STREAMLINED DESIGN REVIEW 2019

10715
Interlake Ave N
Seattle, WA 98133

SDCI # 3035182-LU
6745975-CN
3035565-CN

DOCUMENT: SDR

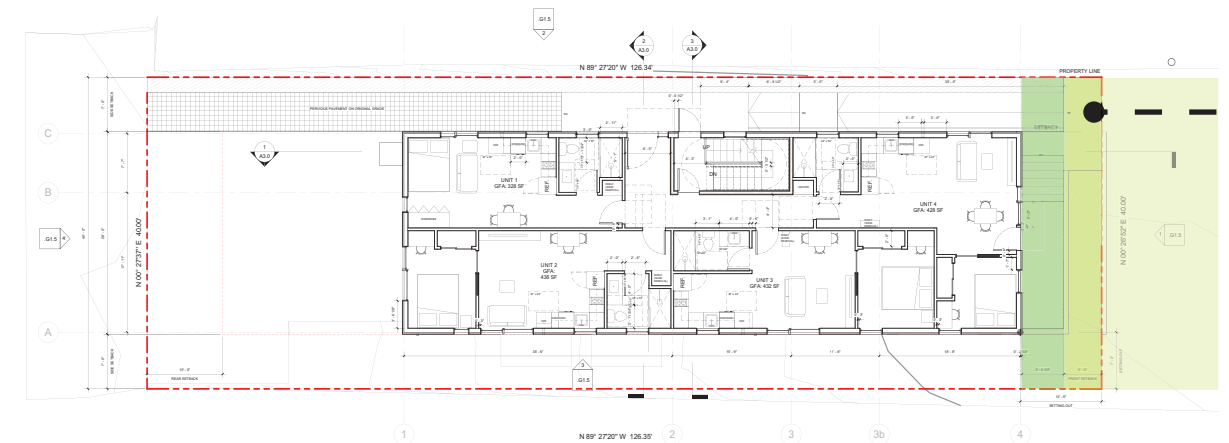
Comment 6) Connect front "patio" to the new front entry, or to the front unit; employ purposeful design.

Response: After shifting to the east, the previous square open patio at front changes to a rectangle front yard. When satisfying requirement of garbage management, a private yard for the front unit is created. The relationship between street and building transits from public, semi-public to private sequence. See diagrams below:

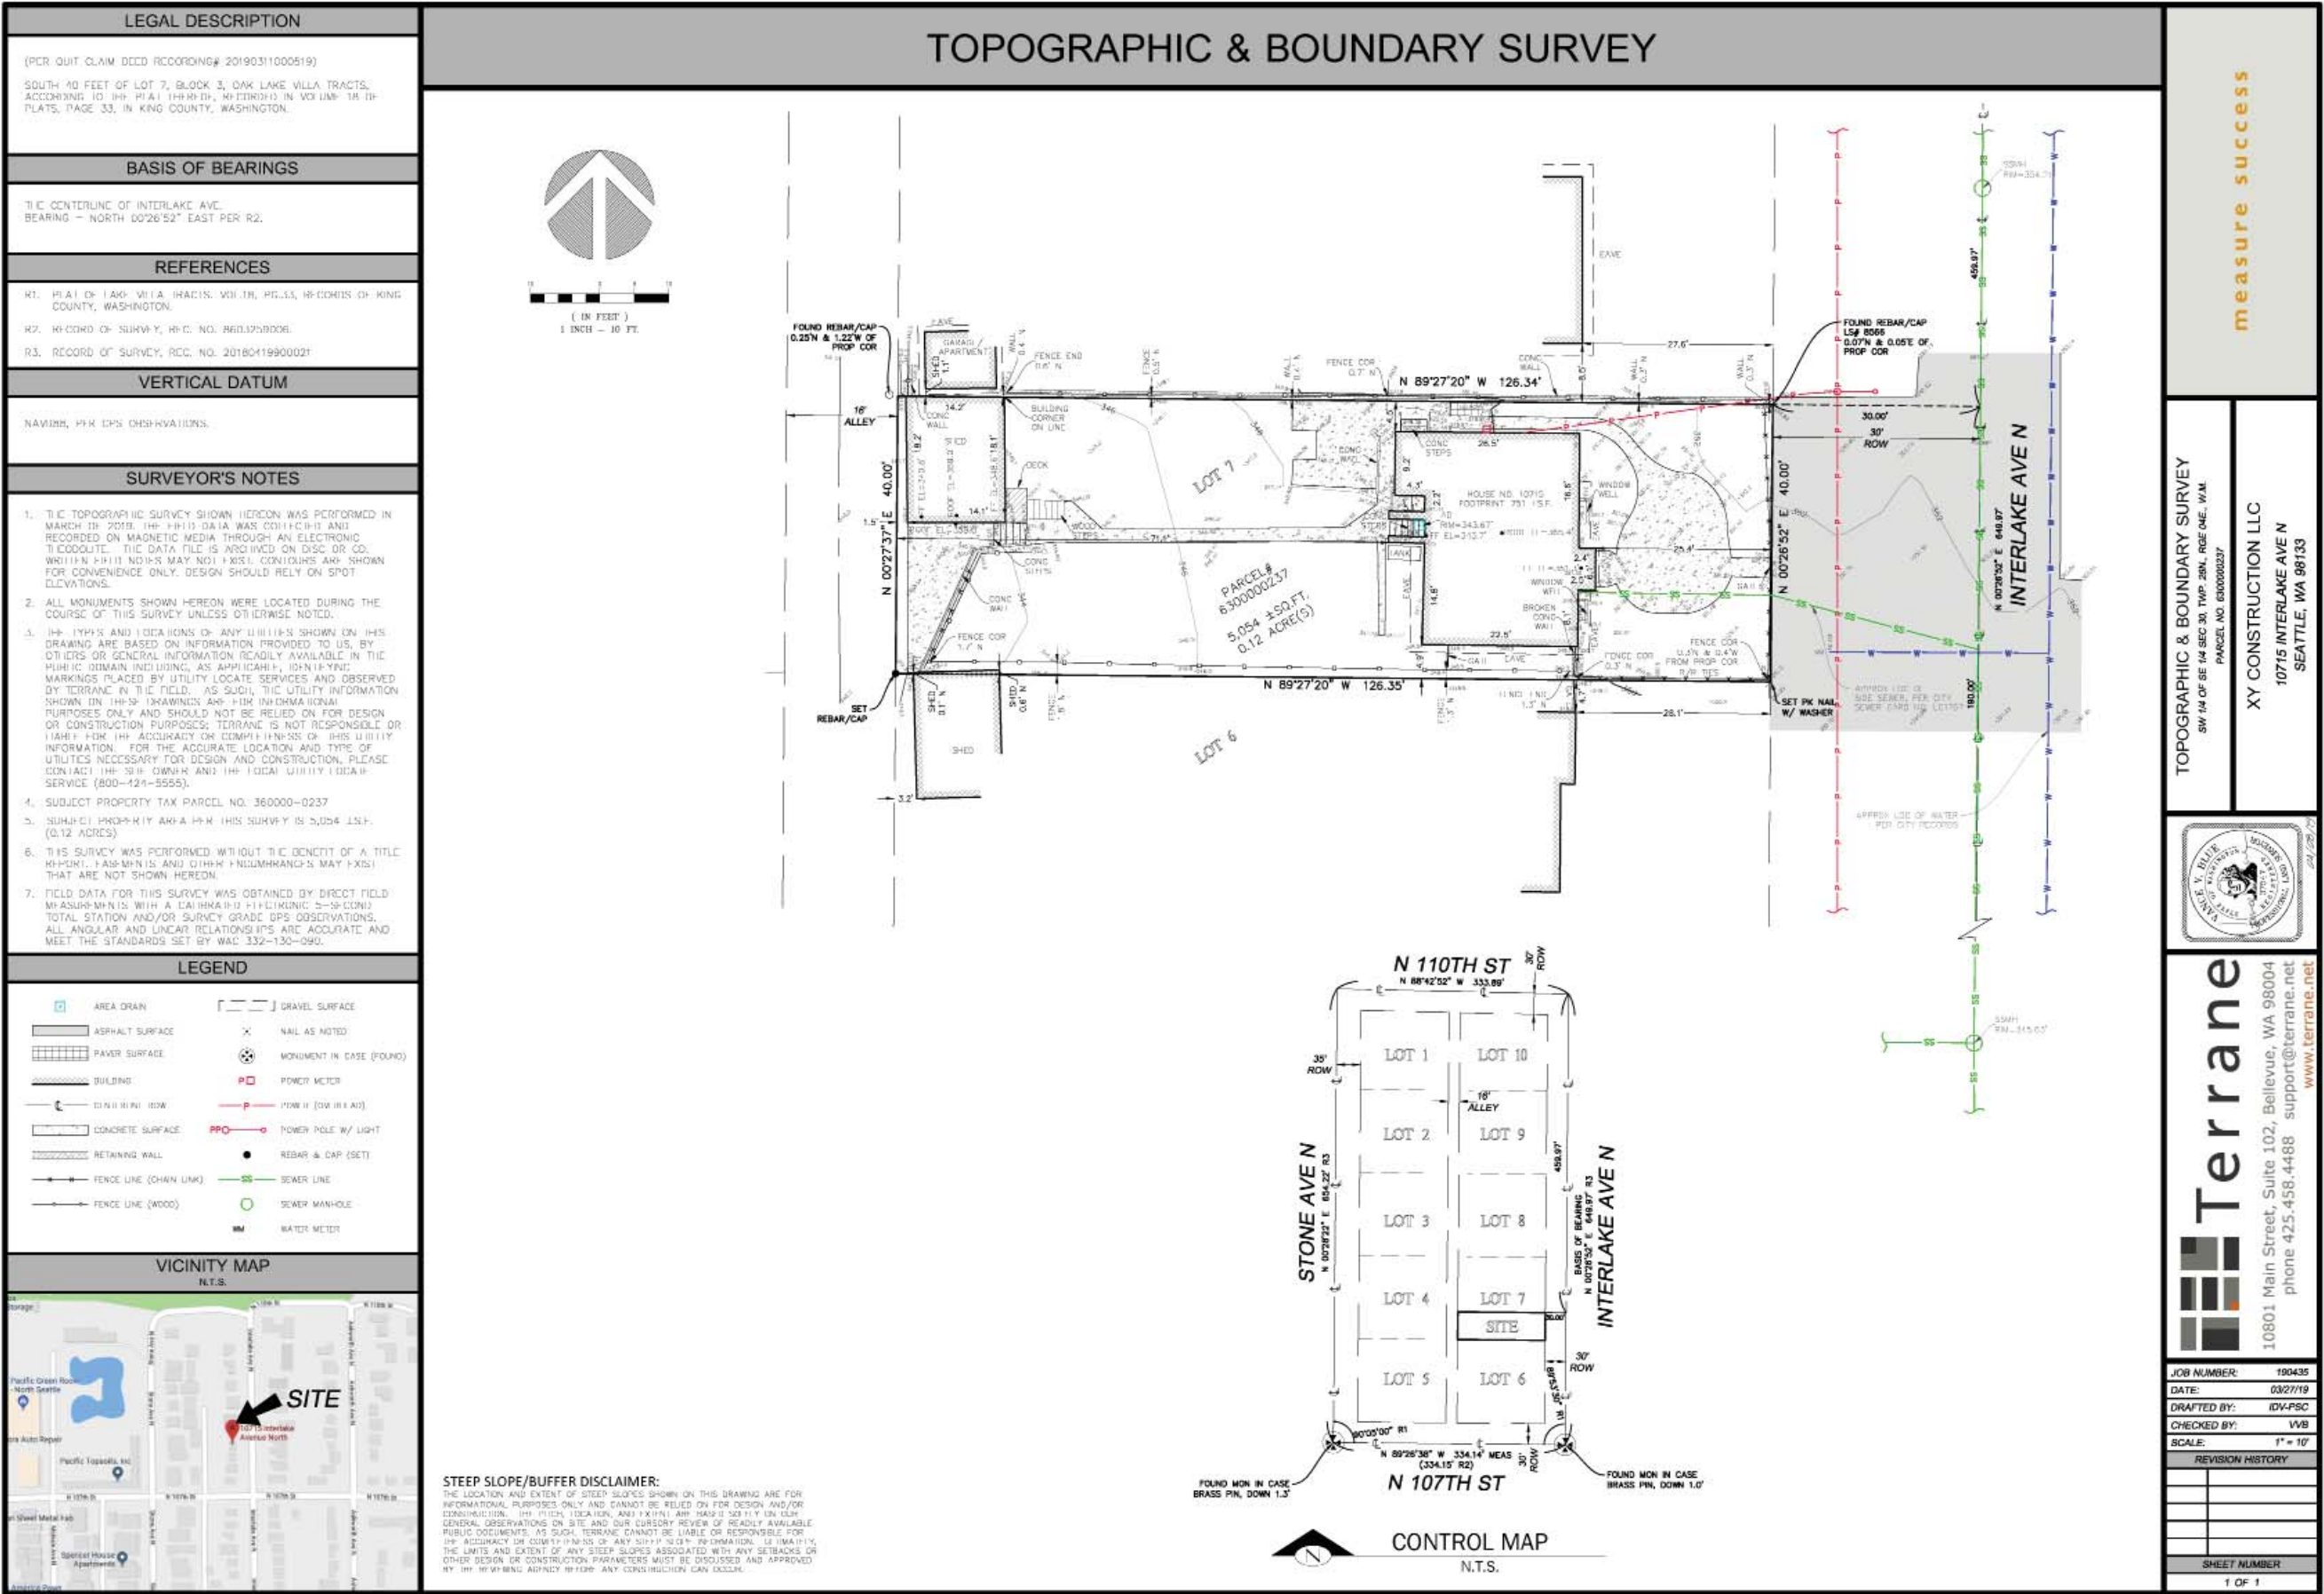
Comment 1) The number of new residents of a 11 apartment might create safety issues if people trespass adjacent sites freely.

Comment 2) Provide parkings due to the reality that people own cars generally in this area.

Response: The site will be fenced and gated at the perimeter. There will be access control when entering from alley and street to the main entrance, to the basement unit, and to the waste dumpster. More detail is illustrated on the site plan on Page 19.

Response: Although this project, which is in Urban Village, is not required to provide parking, there will be two additional parkings provided on the rear yard (see site plan on Page 19) to avoid the overcrowding situation. Public sidewalk is also planned and paved, which will help to decrease accidents by lane differentiation.

SUNLIGHT ANALYSIS

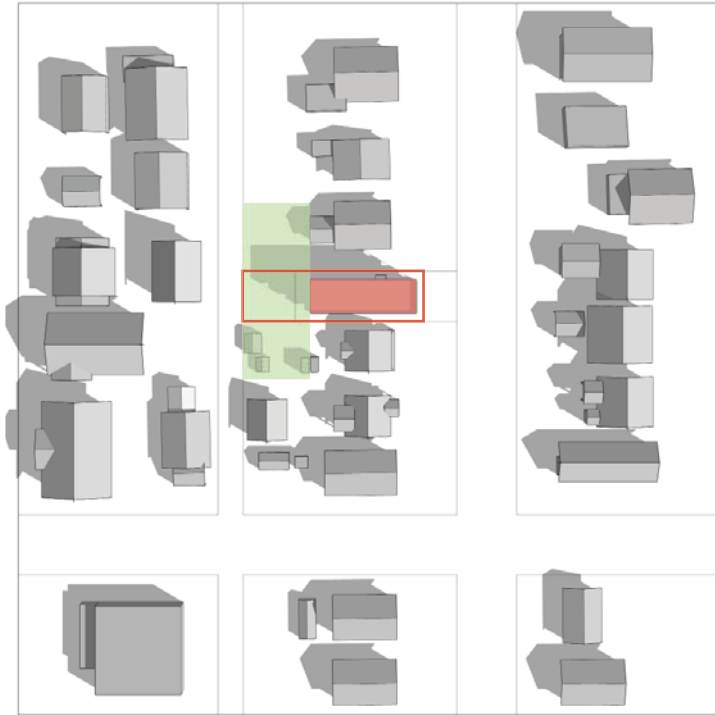
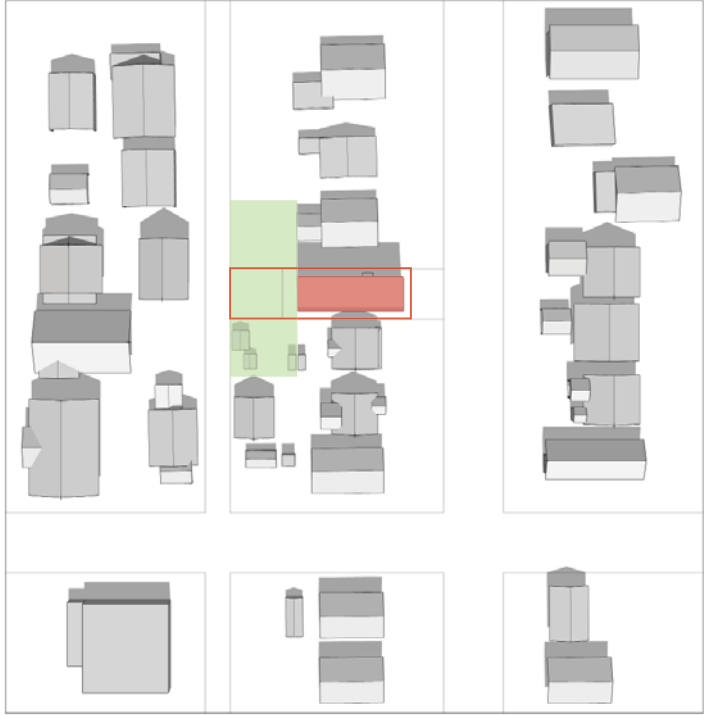
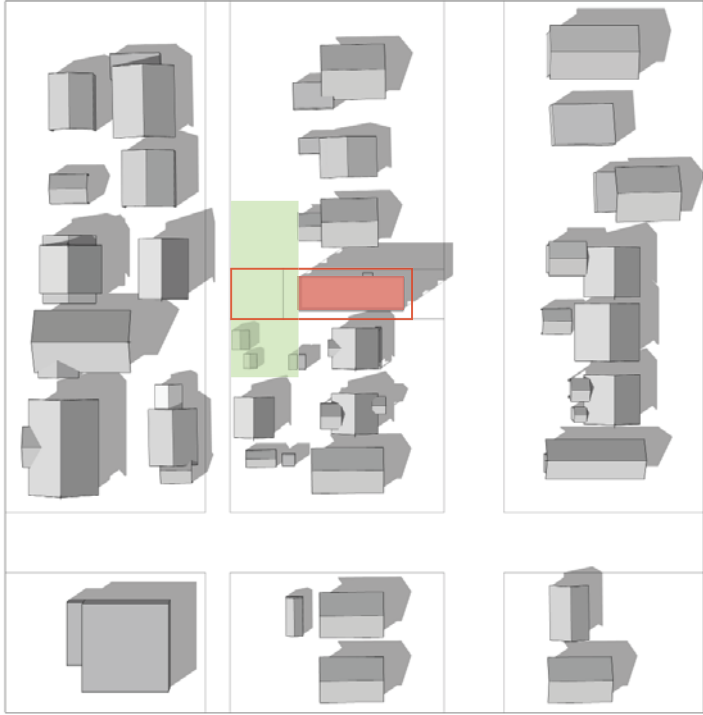
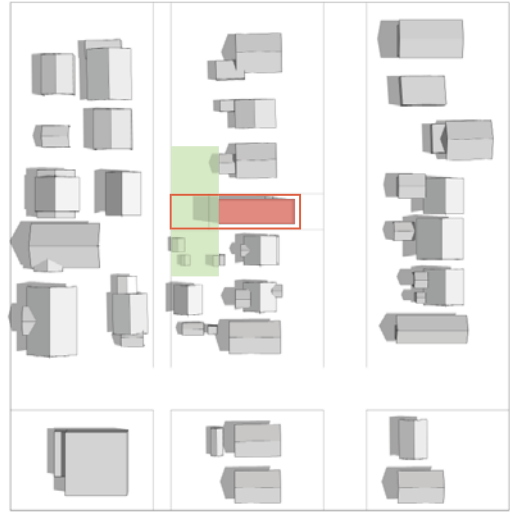
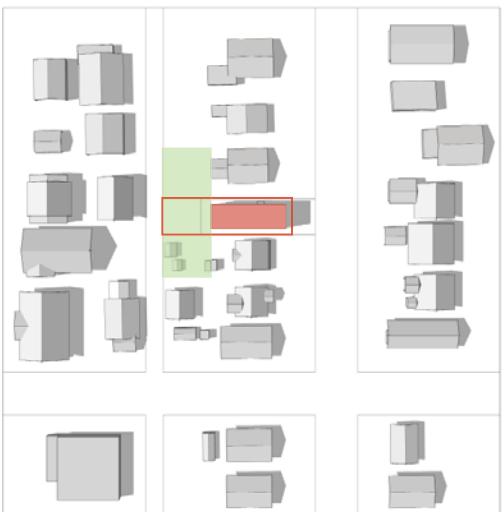
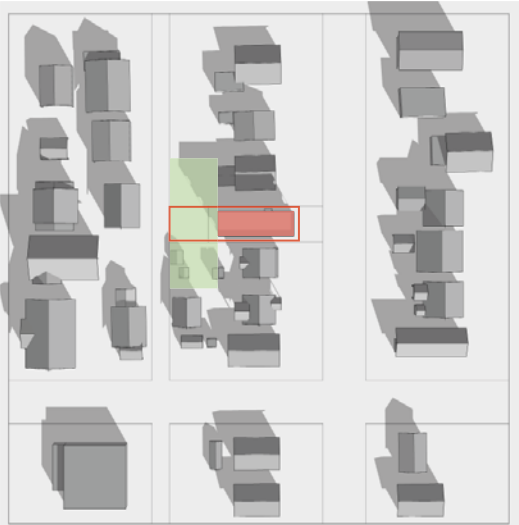
Comment 3) Shift building to the east to achieve the minimal shadow impact to the north.

Response: The building is shifted to the east compared to previous proposal which has a rear back of the min. 10'. Referring to the year-round sun analysis on Page 22, most back yard area of adjacent site is relieved from shadow. In addition, to better respond to current and future context, the current proposal is shifted towards to street to achieve a 10' setback, which would begin to establish the future street wall.
